TECHNICAL NOTE			TN. 02
Revision	3	Date:	1 <sup>st</sup> August 2025
Principal's Representative:	Grant Fahey		
Contractor:	Apex Water		
Contract:	Milldale Wastewater Treatment Plant		
Contract No.:	240805		
Subject:	Technical Note – Response to Requests for Additional Information

### Technical Note – Support of Fulton Hogan Land Development Milldale Consent Application

Prepared by: Apex Water

**Figure 1** Median concentration of key nutrients permitted in the discharge at different discharge flows under the mass load approach

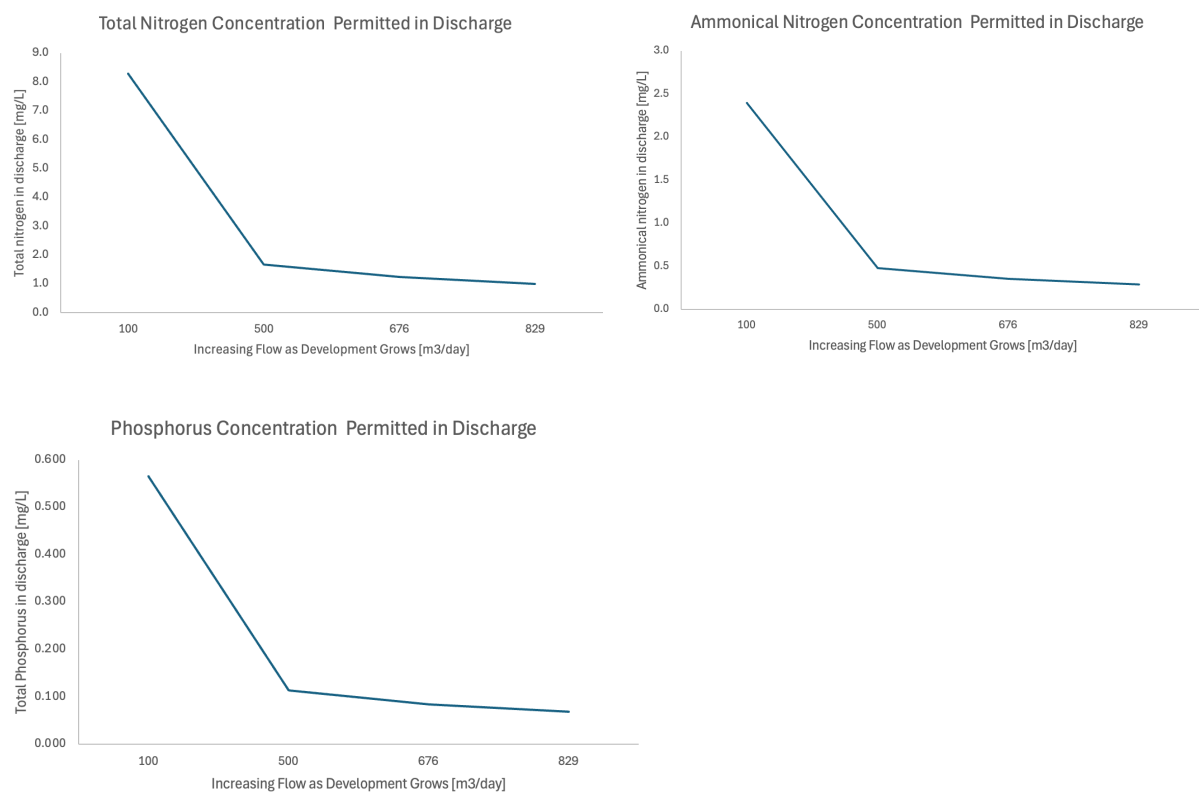
*Condition 59, Wastewater Samples – The sampling frequency is reasonable. However, the consent limits given in condition 53 are 12 monthly medians and it would be good to have some visibility around performance within this time period. It is recommended a condition requiring that Council be alerted if (for example) there are two or more consecutive samples that exceed the median values, with an explanation of what will be done to ensure the limit is met.*

As noted in Reference 2, a move to load-based discharge conditions has been proposed in order to better represent the actual impact on the receiving environment and allow for a discharge flow which will increase over time to be accounted for in the compliance monitoring.

Based on discussions with Council's Experts (Reference 2), it is proposed to update the compliance condition to a mass loading basis, equivalent to the parameter provided in Table 2 when measured at the full design discharge flow of 829m<sup>3</sup>/day. This results in an update of the treated water discharge limit condition values to:

While at full design flow, these limits still require the discharge to meet the extremely stringent concentration limits in Table 2 (by limiting equivalent mass loading discharged), they do provide some operational flexibility to the wastewater treatment plant as the development grows whilst still maintaining the same low ecological impact in the receiving environment as has been modelled for this discharge.

For example, without changing the mass load discharged or subsequent post-dilution in-stream concentration of the determinants in Table 2, the discharge from the wastewater treatment plant could reach the following median nutrient concentration at different flows without breaching the proposed mass loadings:

Figure 3 Flow Diagram of the treatment system showing indicative mass balance during typical dry weather flow at full build out.

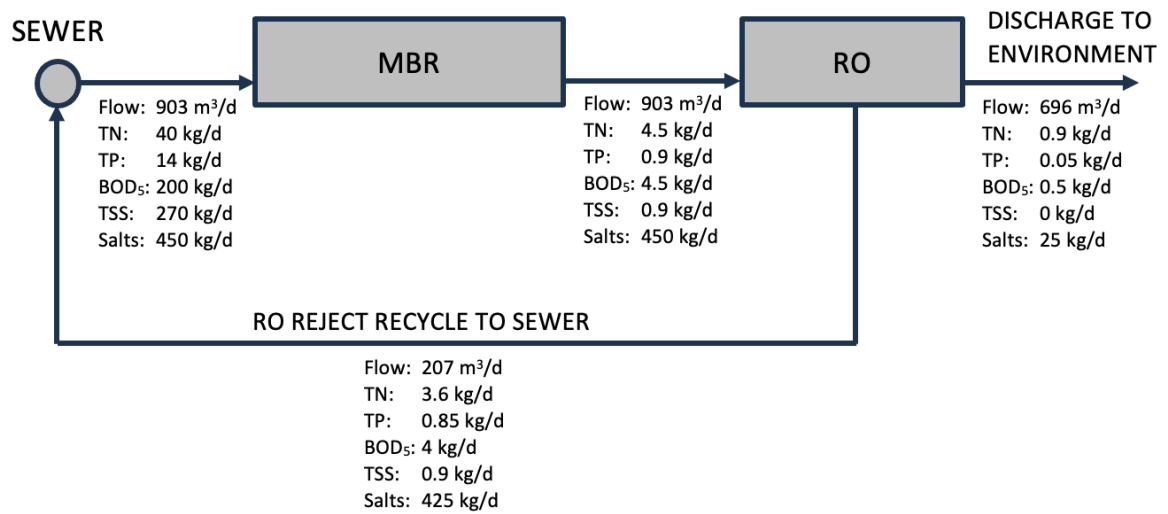
- The composition and variability of the RO waste stream, including concentrations of salts, nutrients, trace contaminants, and any emerging pollutants.

Water removed from the sewer is highly treated by the MBR process before being concentrated in the RO system and discharged back to the sewer. While macro-nutrients, organic contamination and solids are largely removed by the MBR process, inorganic salts are likely to remain. These are retained by the RO and returned to the sewer that they were extracted from.

Figure 3 below shows an example of operation of the treatment plant and Reverse Osmosis system with typical mass balance of macro nutrients and an example of salt loadings from through the process (dependant on incoming salt loading in the sewer).

Based on typical operation of the treatment plant during dry weather flows, the RO reject stream is expected to contain an average of approximately:
